PLANNING BOARD AGENDA FOR JANUARY 13, 2026 - 7:00 PM

1. **Salem NIM, LLC Site Plan** – Public Hearing for change of use for 19,960 sq. ft. restaurant and entertainment use with conditional use permit for reduced parking and additional signage at 11 Mall Road, Map 107, Lot 11154. Continued from 12/9/2025.

Below please find our responses comments discussed in our December 9, 2025 meeting and at the PB meeting. Below please find each comment followed by our response in **bold**.

Site Development Plan For:
LYONS GROUP RESTAURANT
AT THE MALL AT ROCKINGHAM PARK
11 MALL ROAD
SALEM, NH

TM101 | GARBAGE TRUCK MOVEMENT PLAN

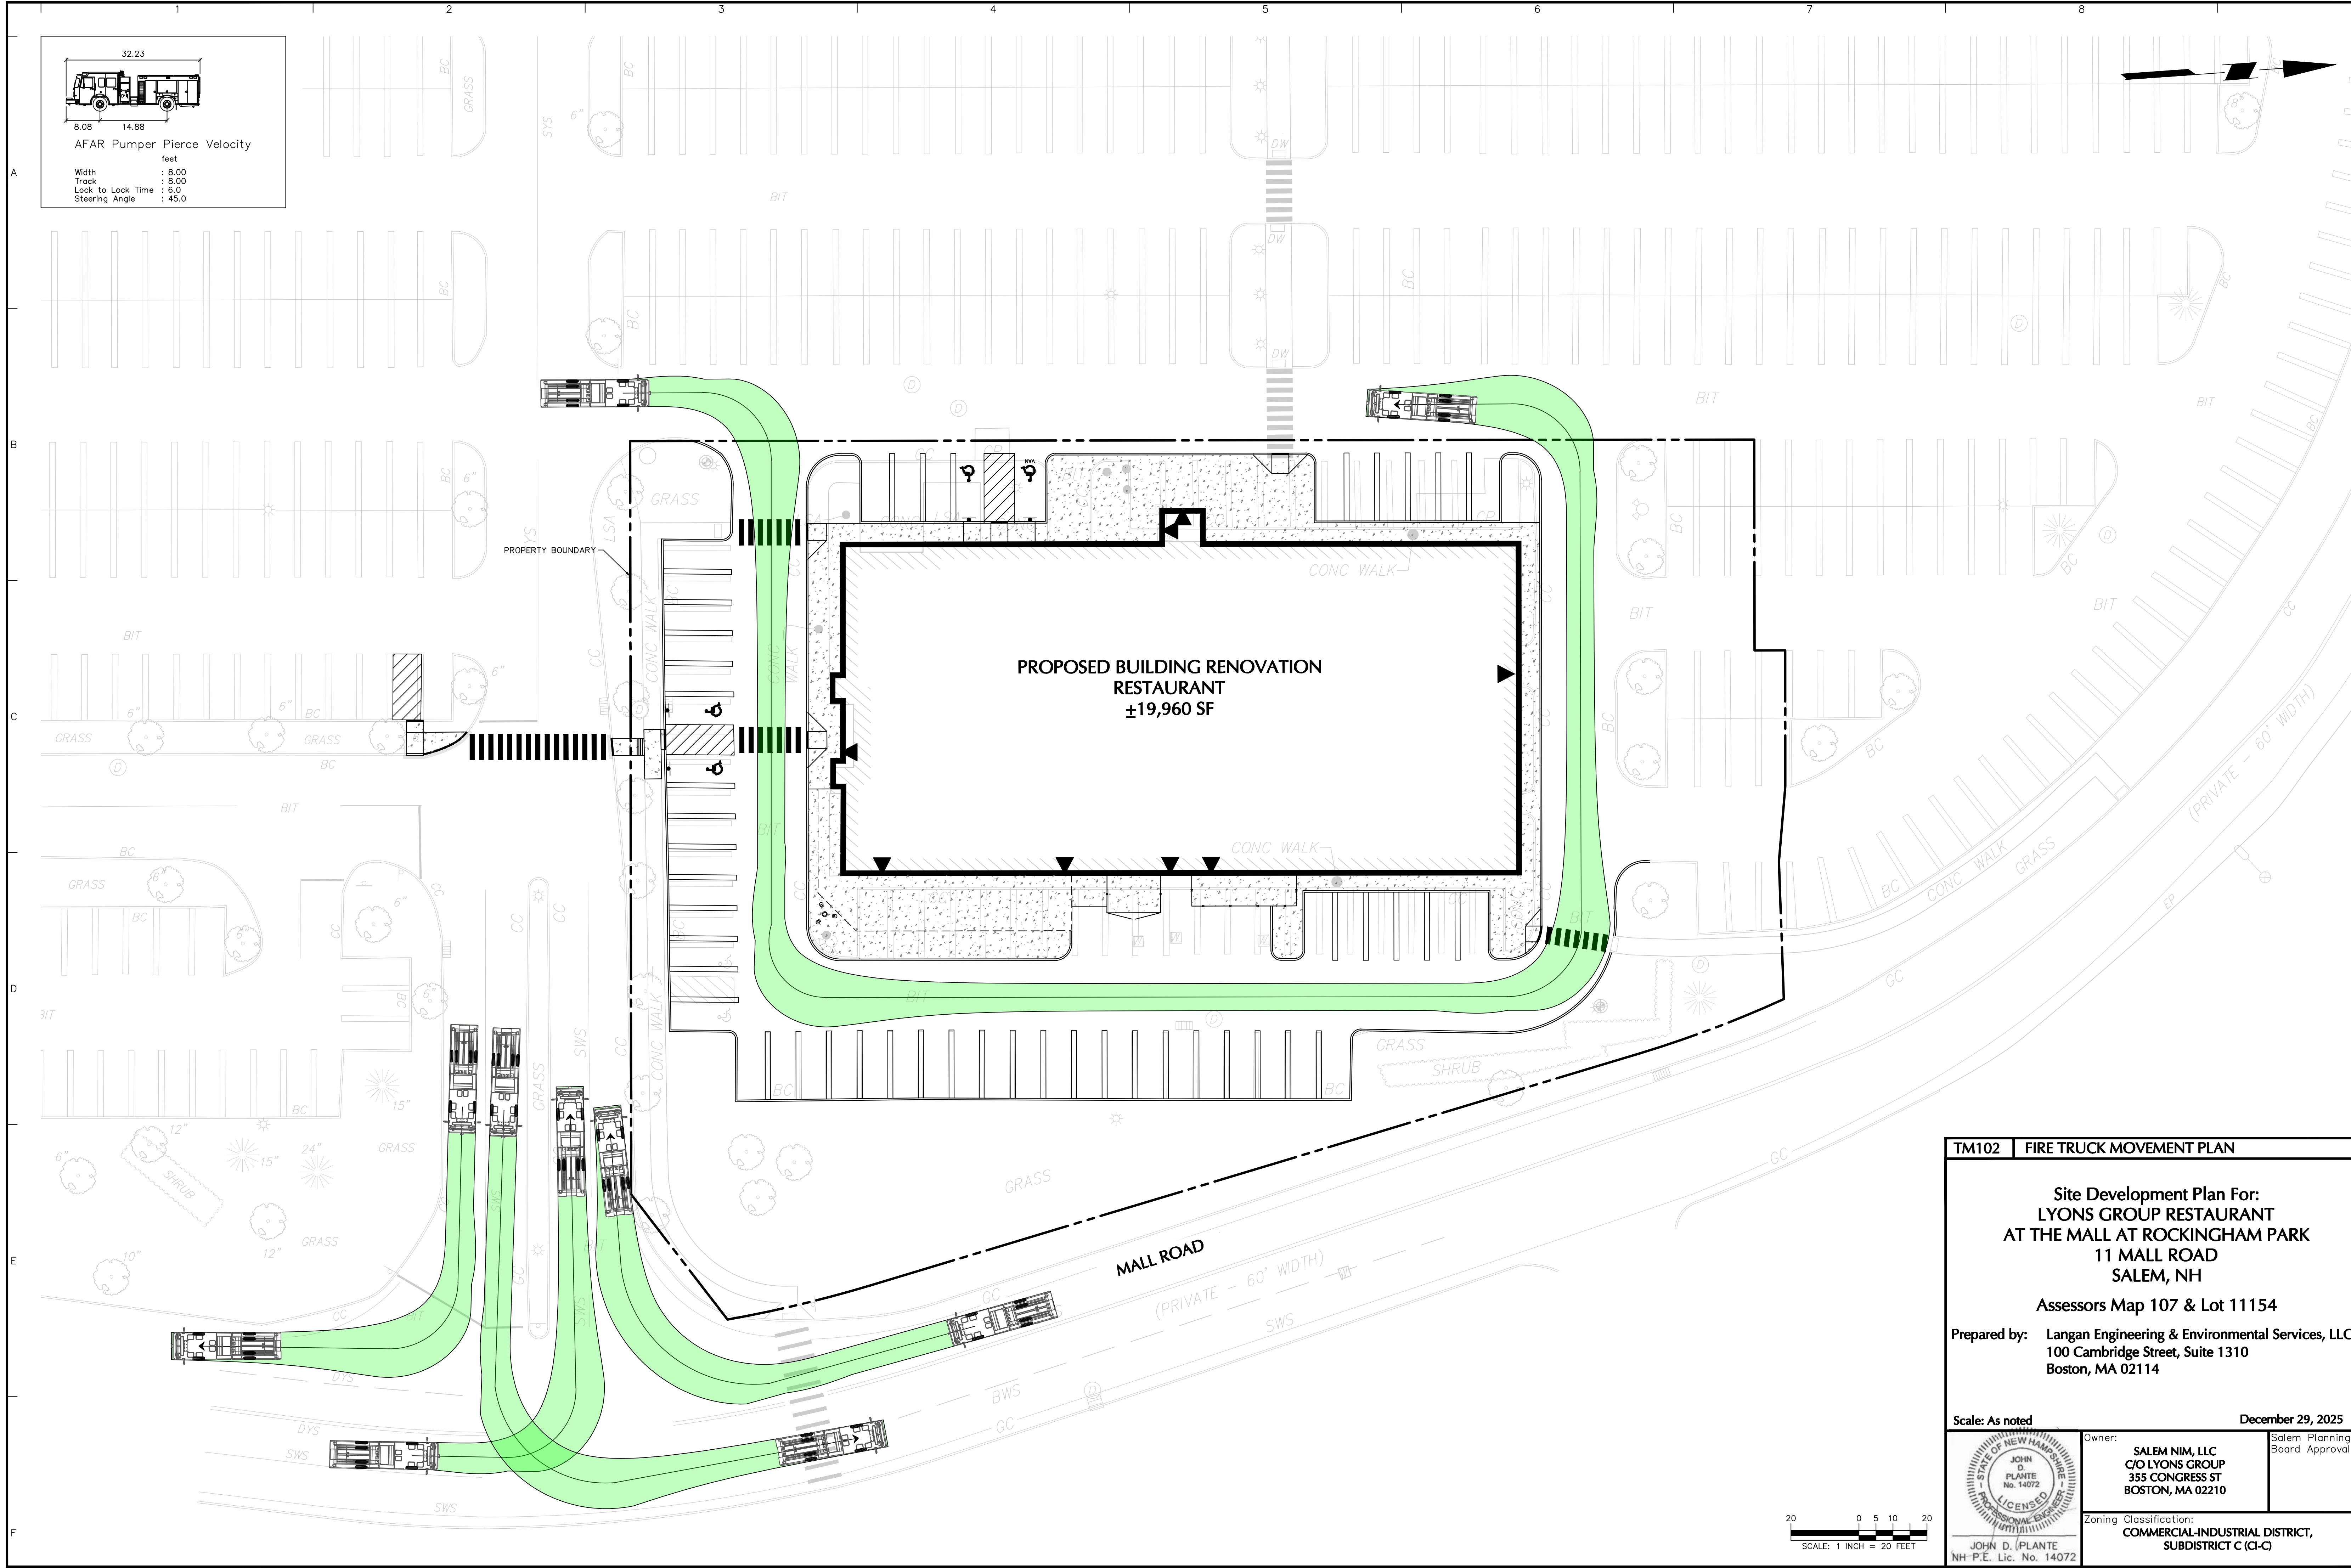
Site Development Plan – A vehicle tracking analysis should be prepared that demonstrates: 1) compatibility with Salem fire apparatus, and 2) how the dumpsters will be serviced. According to Sheet CS101, 68 spaces are proposed within the subject site. It should be noted that the peak parking demand estimates range from 158 to 395 occupied spaces. This means that there is the

COMMENT RESPONSE: Truck turning plan has been added to the set on TM101.

COMMENT RESPONSE: *Vehicle turning movement demonstrations are provided on Sheets TM101 and TM102. The 85th percentile (peak) parking estimates for Loretta's and Game On! are 266 spaces, which is 71% of the available parking spaces within Lot C1.*

LP101 | PLANTING PLAN

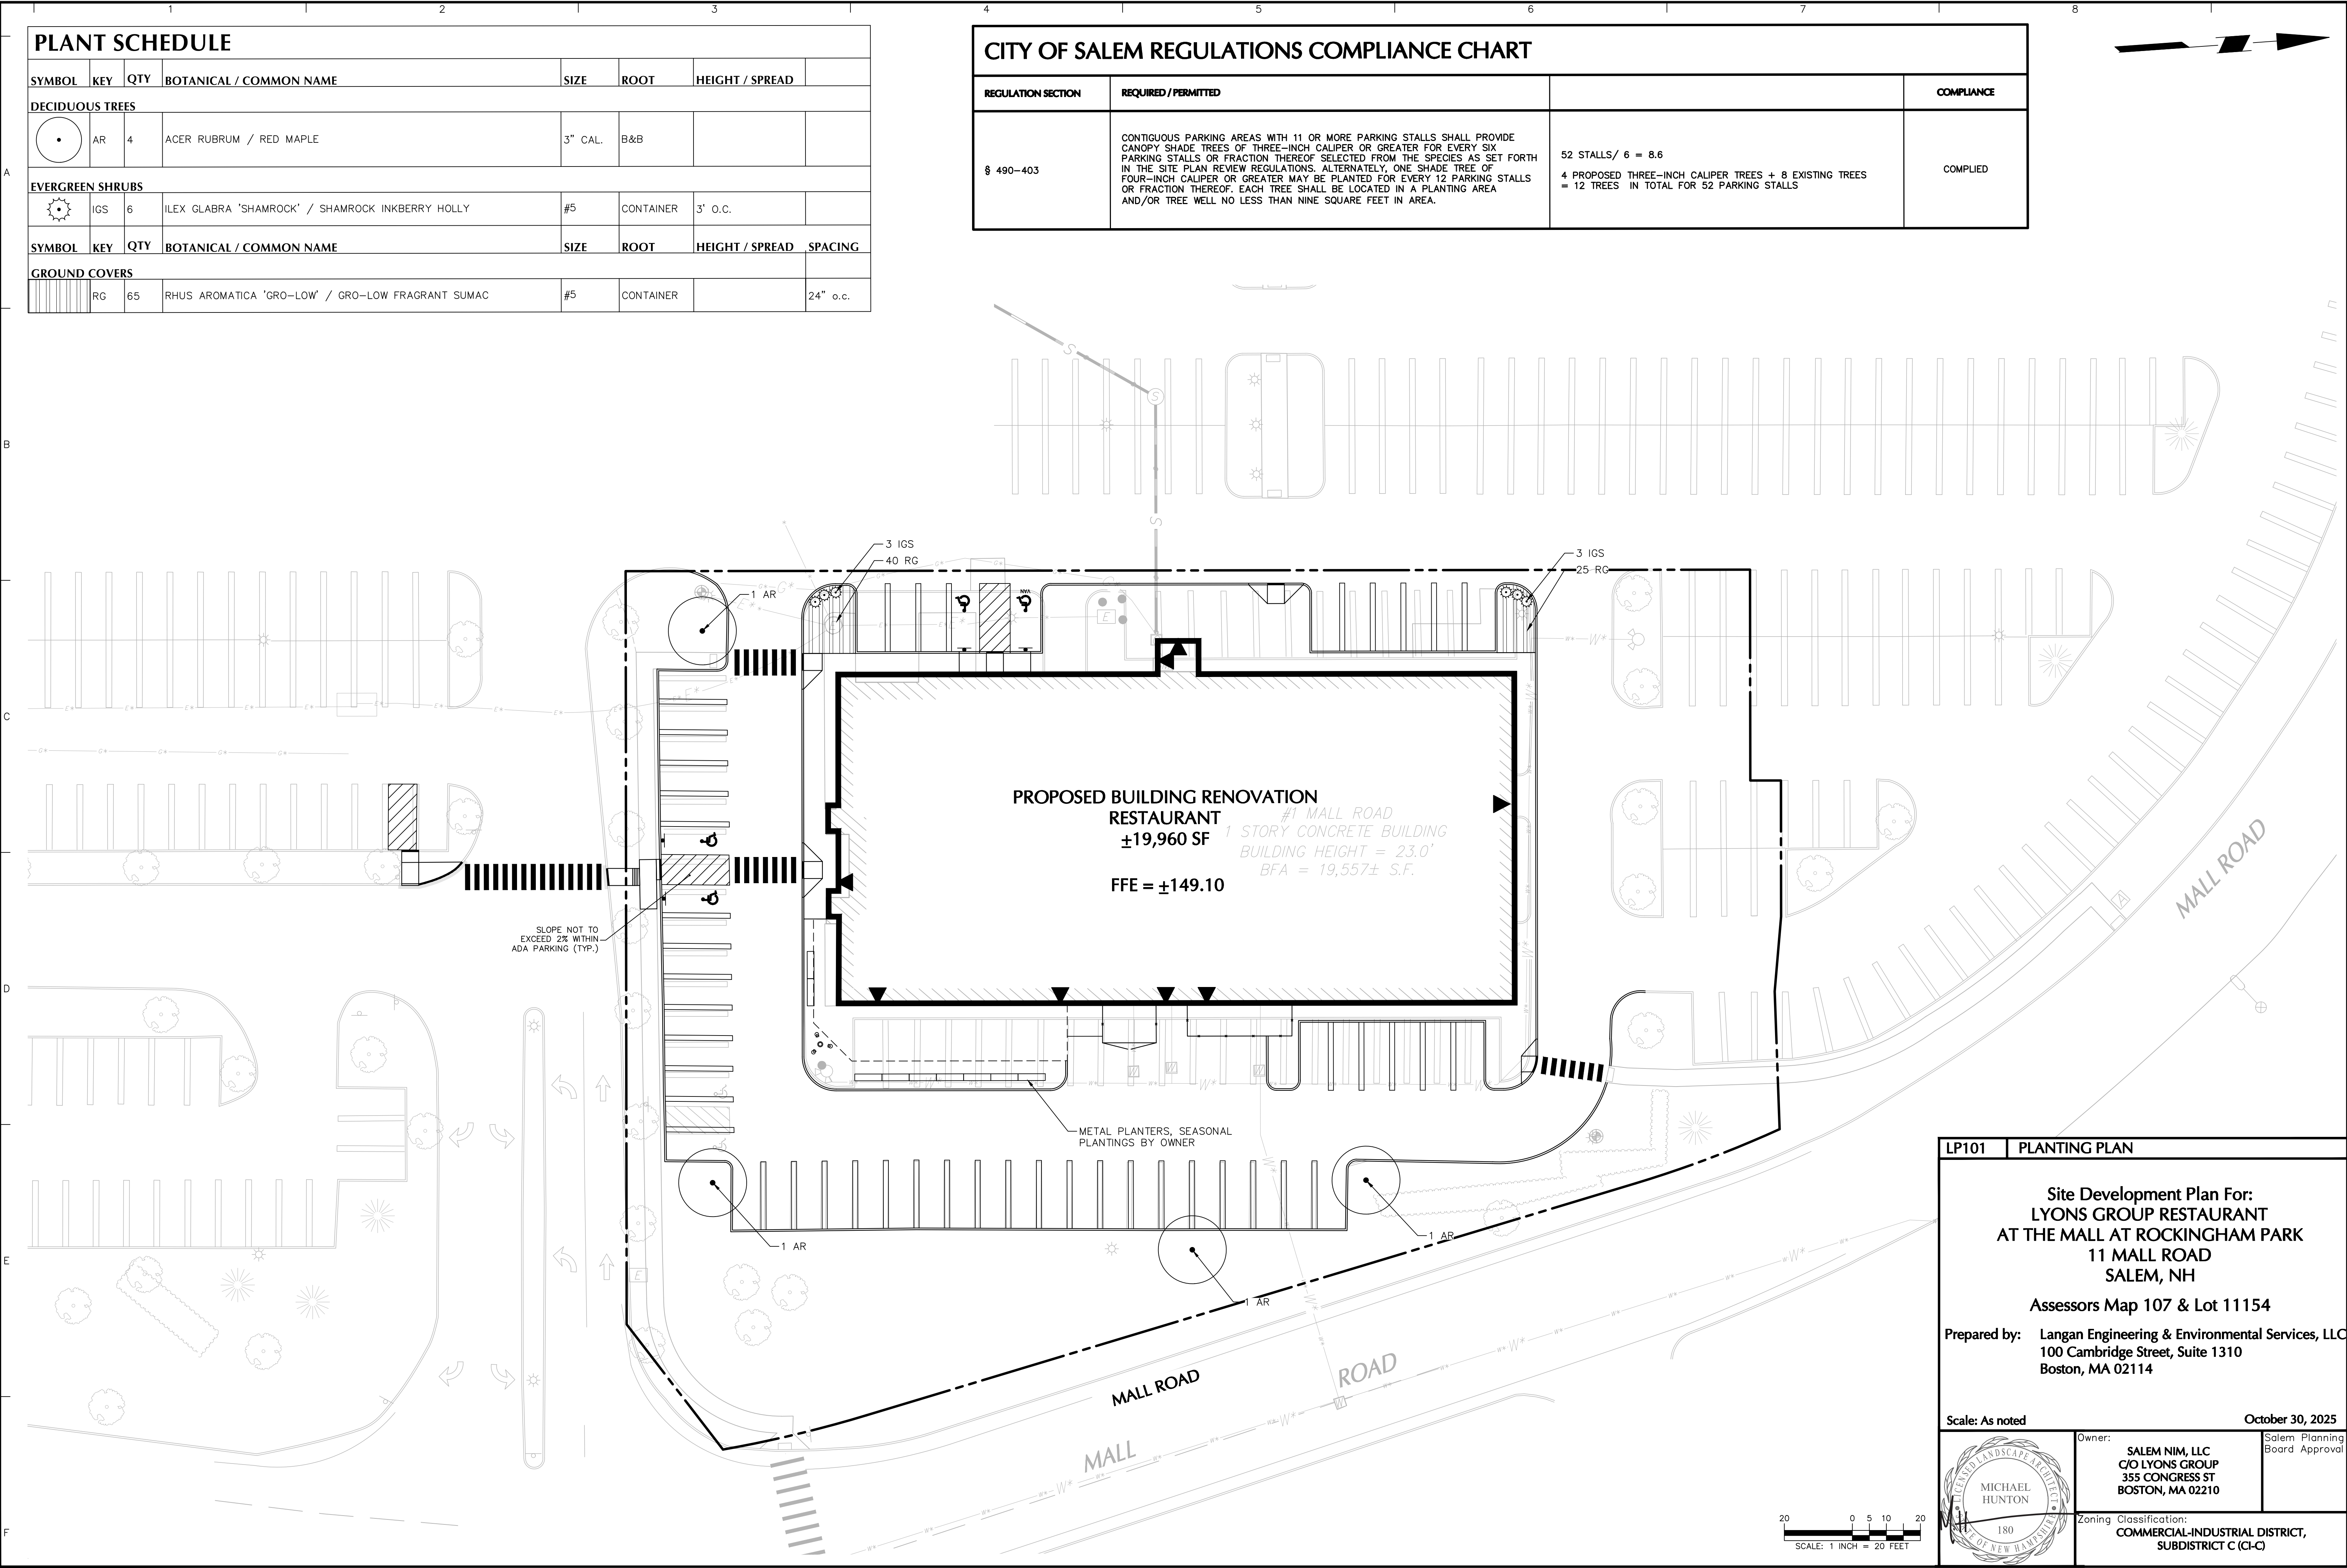
- Show existing landscaping in addition to proposed – Design Guidelines state “parking lots with 10 or more spaces should have at least one tree per eight spaces, planted in or within five feet of the lot... Larger and more visible parking lots should have more intensive landscape treatments.

COMMENT RESPONSE: Regarding the landscaping comments for the Lyons Group project, we would like to clarify that the proposed design actually decreases the total parking count by 16 spaces. This reduction means the project is well within the required thresholds; however, we are still proposing additional trees beyond the required one per eight spaces minimum.
